RE: DEQ Comments on Phase III PFAS Work Plan
Portland Air National Guard
ECSI# 1372

Oregon DEQ staff completed review of the *Work Plan for Fiscal Year 2017 Phase III, Regional Site Inspection for Perfluorooctanesulfonate and Perfluorooctanoic Acid at Portland Air National Guard Base, Portland, Oregon*. The work plan was prepared by Leidos for the Air National Guard, Restoration Branch and dated January 2018.

Re: Review Comments
Site Inspection Work Plan for PFOS and PFOA (Draft Final)
Portland Air National Guard
February 2018

Draft Final Portland Site Inspection Work Plan (SI WP) for Perfluorinated Compounds (PFCs) Phase III
Portland Air National Guard Base, Portland, Oregon
January 2018

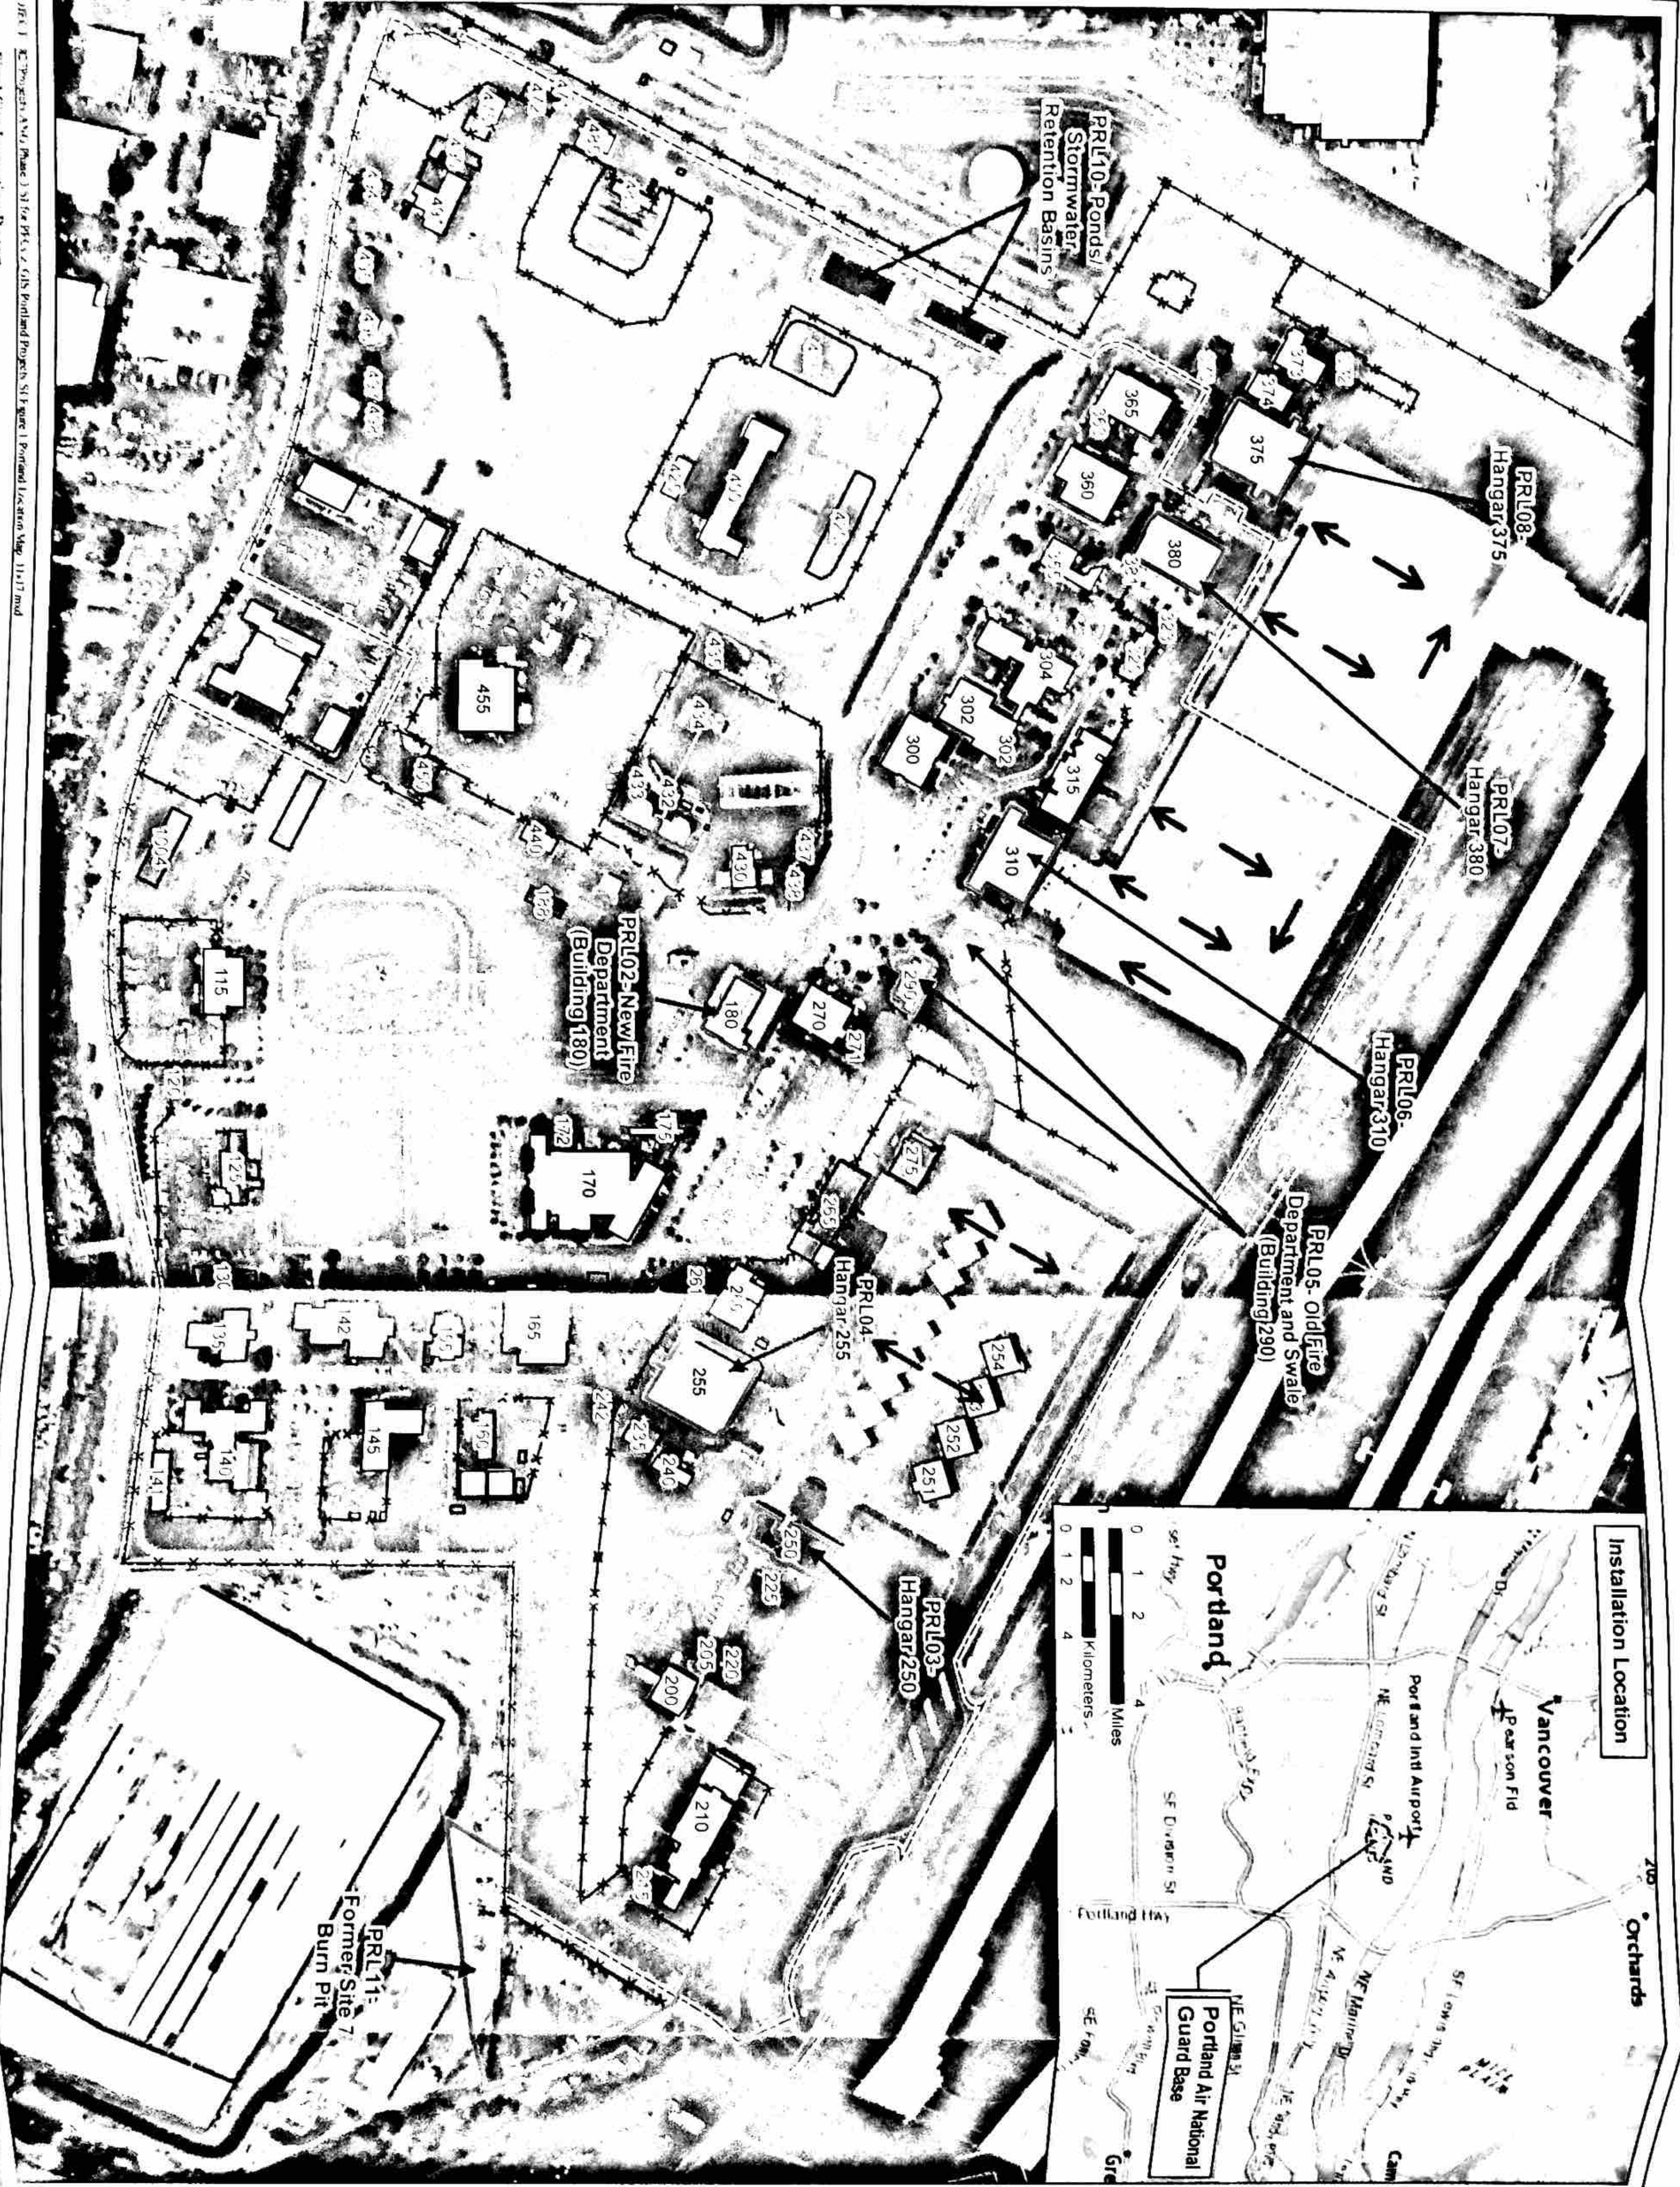
1. Section 3.5. There are a series of man-made "drainage ditches" present within the confines of the PANG base which are inundated on a year-round basis which collect and route stormwater runoff (and shallowest groundwater) to on-site treatment ponds, and ultimately discharge to nearby Columbia Slough to the south. These features are non-navigable. There are expected to be some ecological organisms associated with these features, while Columbia Slough is an important habitat area and is used for recreational purposes. Please expand and clarify this discussion, and consider including a figure showing the drainage "path" from the base to the Slough.

The surface water drainage pathway from the base to the Columbia Slough will be added to Figure 1-1.
